Access Compliance Report

Public Rights-of-Way

(Curb Ramps)

Intersection ID: 2778	Main Street: HIGHLAND_CREEK_PY	Cross Street: BRADWELL_DR	Location: SW
ADA ID: C853257184A1	Ramp Type: BlendTrans1	Initial Pass/Fail: Fail	Overall Compliance: No
			Severity Score: 33.75

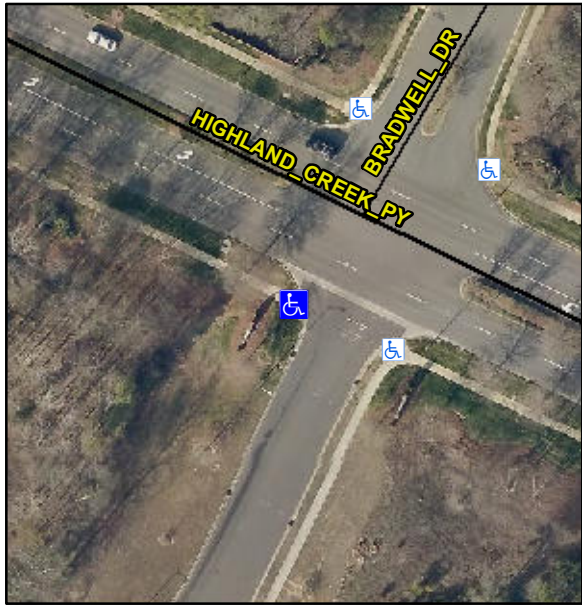
Codes/Mitigation Info/Possible Solution			Field Measurements/Component Compliance					
	Possible Solutions:		Compliance	Description	Data	Compliance	Description	Data
	Remove & Replace Curb Ramp With Two New Directional Ramps or Equivalent.		N/A	Ramp Length (in)	67.0	Yes	BlendTrans Slope (%)	3.2
			No	Ramp Width (in)	47.5	No	BlendTrans XSlope (%)	7.0
			N/A	Flare Type LT	N/A	N/A	Flare Type RT	N/A
			N/A	Flare Slope LT (%)	N/A	N/A	Flare Slope RT (%)	N/A
			N/A	Flare Traversable LT?	N/A	N/A	Flare Traversable RT?	N/A
			N/A	Landing Length (in)	N/A	N/A	DWS Provided?	N/A
			N/A	Landing Width (in)	N/A	N/A	DWS Contrast?	N/A
			N/A	Landing Slope (%)	N/A	N/A	DWS Length (in)	N/A
			N/A	Landing X Slope (%)	N/A	N/A	DWS Full Width?	N/A
Surveyor Notes:		N/A	N/A	Landing Curb? (Y/N)	N/A	N/A	DWS Offset (in)	N/A
PROW/ADA:		Not Found, R304.5.1, R304.5.3	N/A	Shared Landing?	N/A			
			N/A	Gutter Ponding?	N/A	N/A	Gutter Slope (%)	N/A

N/A	Gutter Lip Ht (in)	N/A	N/A	Gutter X Slope (%)	N/A
			N/A	Painted X Walk1?	Yes	N/A	Painted X Walk2?	No
				X Walk 1 Direction	To SE		X Walk 2 Direction	To NE
				X Walk 1 Width (in)	62.0		X Walk 2 Width (in)	N/A
				X Walk 1 Slope (%)	1.9		X Walk 2 Slope (%)	1.8
				X Walk 1 X Slope (%)	8.9		X Walk 2 X Slope (%)	1.6
			N/A	Ramp inside XWalk1?	Yes	N/A	Ramp inside XWalk2?	N/A
				Road Slope (%)	8.3		Clear Space?	N/A
				Road X Slope (%)	2.9	N/A	Clear Space to XWalk (in)	N/A
			N/A	Any Obstructions?	N/A	N/A	Storm Grate/Utility Hazard?	N/A
				Obstruction Type			Storm Grate/Utility Type	
					N/A			N/A
						Yes	Surface Condition? (G/P)	Good
						No	Curb Slope (%)	7.1
						</
